# P802.3bq Rx CMNR ad hoc activity - Annex 113A (Informative)

Pete Cibula, Intel Corporation  
P802.3bq Rx CMNR ad hoc chair

Bonita Springs, FL – September 2015

# “NOTE 1” Test Configuration, D2.2

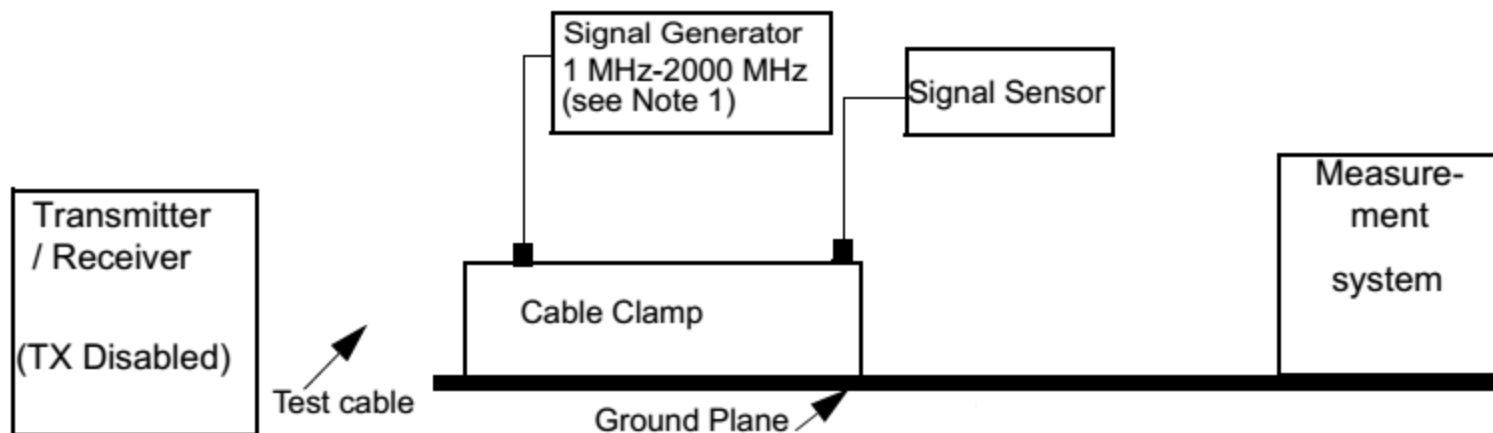
- Participants highlighted that there is a risk of applying excessive impairment levels when compensating for these losses, and that the language in P802.3bq D2.2 (“must”) is restrictive.

- Discussion noted that the validation process outlined in 113A.3 and the limits identified in Table 113A-2 provide a check against this risk
- Ad hoc resolution is trending to changing “must” to “may” to allow some flexibility in implementation.

- A proposed and believed to be helpful note states “If used, the signal power correction factor should not result in common-mode and differential-mode voltages that exceed the limits defined in Table 113A-2.”

Figure 113A-3—Cable clamp validation test configuration

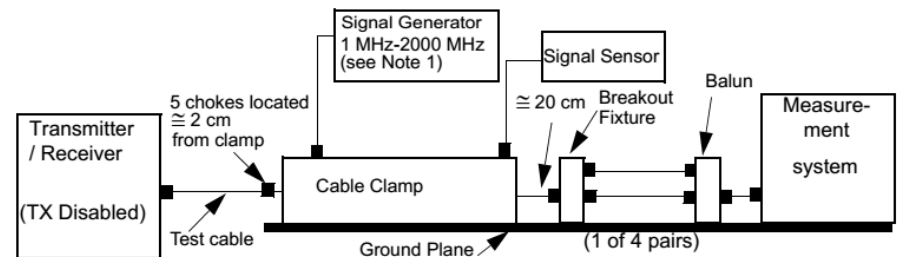
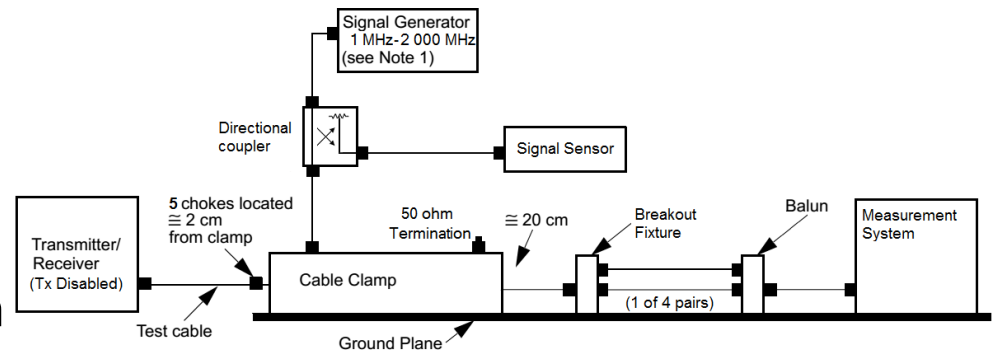
- Technical contributions have identified several advantages with measuring the injected signal power at the source using a directional coupler
- The suggestion is in line with generally accepted good measurement practice and not viewed as restrictive or burdensome
- An example of suggested figure changes are shown
- Accompanying text has been proposed in comments but not reviewed

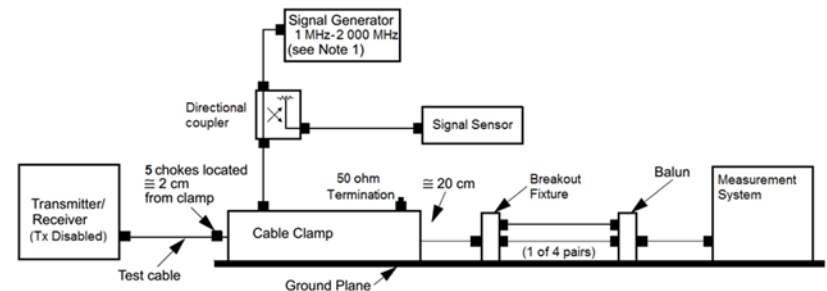
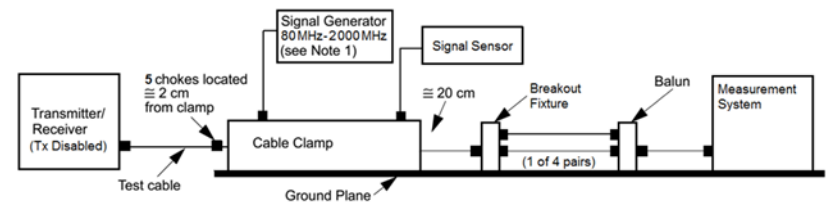
- Add new text after P205 Line 2 and change existing “j)” to “k)”

- Change Figure 113A-3 - Cable clamp validation test configuration to use a directional coupler
- Comment deferred to BZ discussion

j) Directional coupler:

Mainline Insertion Loss: < 2.5 dB (1 MHz-2000 MHz)

Coupling Loss: < 20 dB (1 MHz-2000 MHz)

Return Loss (Mainline Ports): > 16 dB (1 MHz-2000 MHz)

Return Loss (Coupling Port): > 15 dB (1 MHz-2000 MHz)

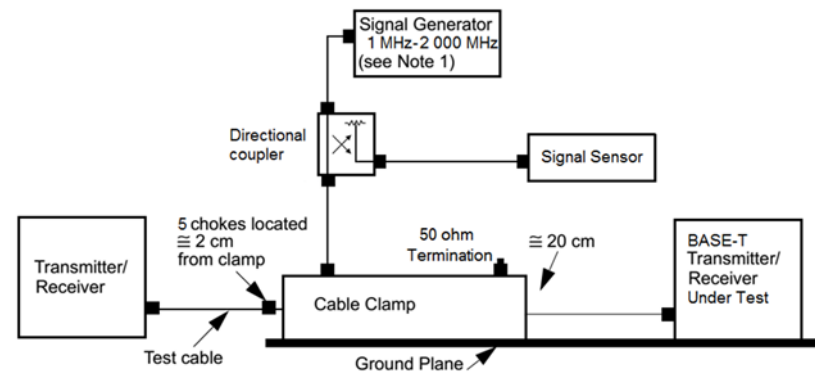
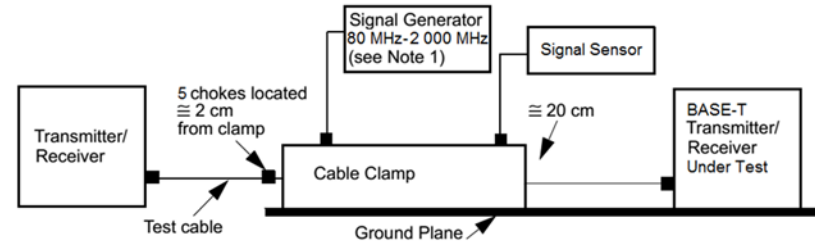
- Change Figure 113A-4 - Cable clamp test configuration to use a directional coupler
- Comment deferred to BZ discussion
